# UNITED STATES PATENT AND TRADEMARK OFFICE

APPLICATION NO.	FILING DATE	FIRST NAMED INVENTOR	ATTORNEY DOCKET NO.	CONFIRMATION NO.
10/797,839	03/10/2004	John R. Blake	47171-00390USPT	5664
41230 7590 03/03/2008 CUMMINS-ALLISON CORP. C/O NIXON PEABODY LLP 161 N. CLARK ST., 48TH FLOOR CHICAGO, IL 60601			EXAMINER MCCLAIN, GERALD	
			ART UNIT 3653	PAPER NUMBER
			MAIL DATE 03/03/2008	DELIVERY MODE PAPER

<b>Office Action Summary</b>	<b>Application No.</b> 10/797,839	<b>Applicant(s)</b> BLAKE ET AL.	
	<b>Examiner</b> GERALD W. MCCLAIN	<b>Art Unit</b> 3653

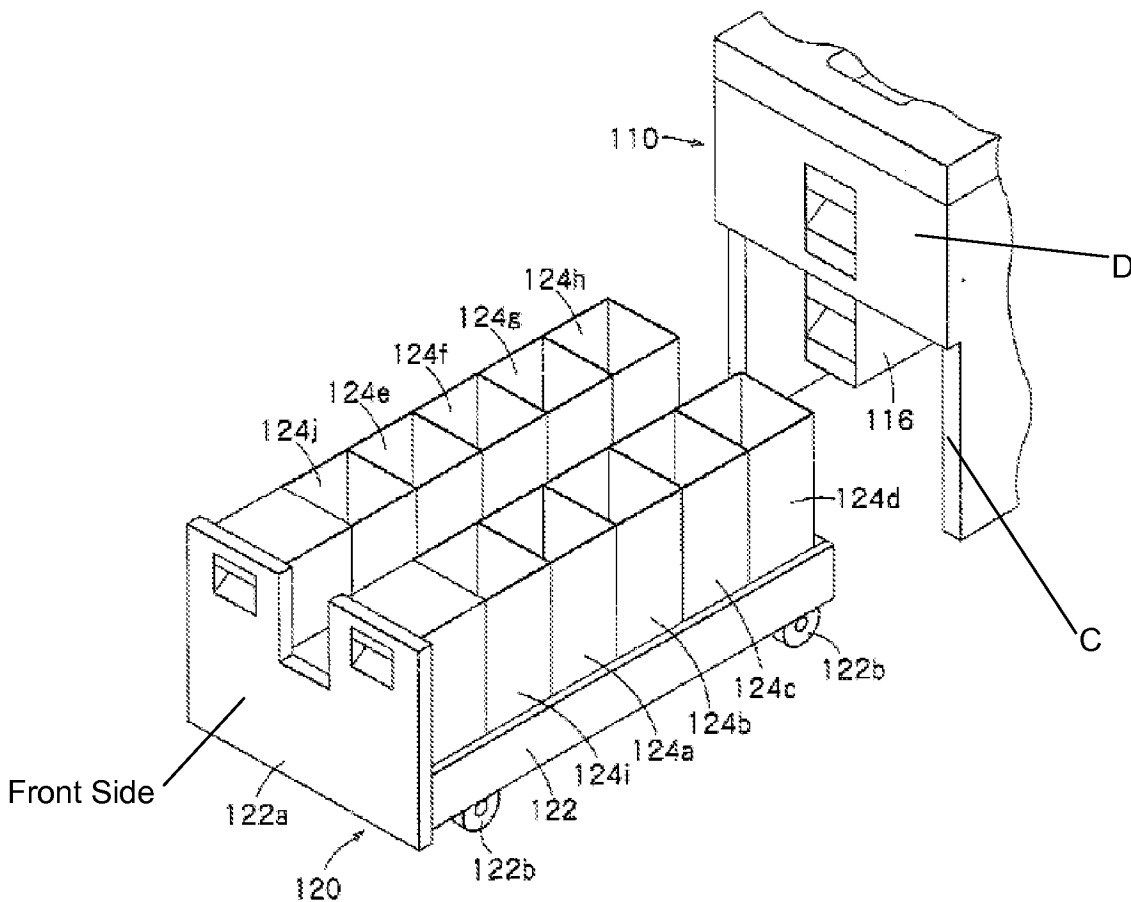
Claim 1: housing (See FIG. 2, 110); coin sorter (S); input hopper (112); rotatable disk (2); stationary head (1); lower surface ([0137]); shaped regions (10); exit channels (8a to 8c); coin receptacle station (120); coin receptacles (124a to 124j); first position (FIG. 2); second position (FIG. 4); manifold (location of 152); coin paths (152); dampening mechanism (See FIG. 4 below, C & 122a and 122b);

Claim 4: dampening mechanism (See FIG. 4 below, C and 122a); coin receptacle station (120); first end (See FIG. 4 below, C); housing (110); second end (See FIG. 4 below, Back Side (opposite Front Side) of 122a).

Claim 15: rear side (See FIG. 4 below, D); housing (See FIG. 2, 110);

Claim 16: front side (See FIG. 4 below, D; Note: the location of D can be defined as the rear or front side); housing (See FIG. 2, 110);

In the closing movement, C & 122a create a damping force at the *end* of the movement (Note: the *entire* movement was not claimed). For the opening movement, either the (1) operator or some other structure that stops the movement generates damping force at the *end* of the movement or (2) the wheels 122b create friction, or a dampening force during the entire movement. Further, the sides of the interior of 110 and the outside rail of 122 are capable of producing friction, or dampening force during the movement. (Argument B)

FIG. G1

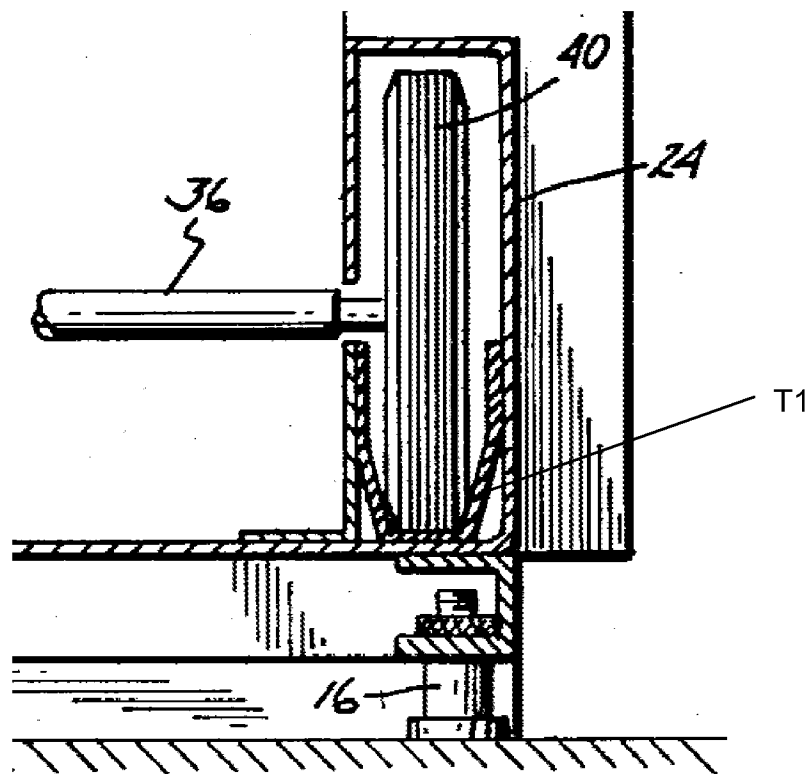
Muellner shows a similar device having a track (see FIG. G1 below, T1) for the purpose of receiving and capturing the casters (column 2, lines 57-66). Therefore, it would have been obvious to a person having ordinary skill in the art at the time the invention to modify Hino as taught by Muellner and include Muellner's similar device having a track for the purpose of receiving and capturing the casters.

Regarding the track T1 above, note that it is applied directly under the wheels of Hino. Therefore, 122 is directly over the track and wheels (See FIG. 3 of Hino, 122).
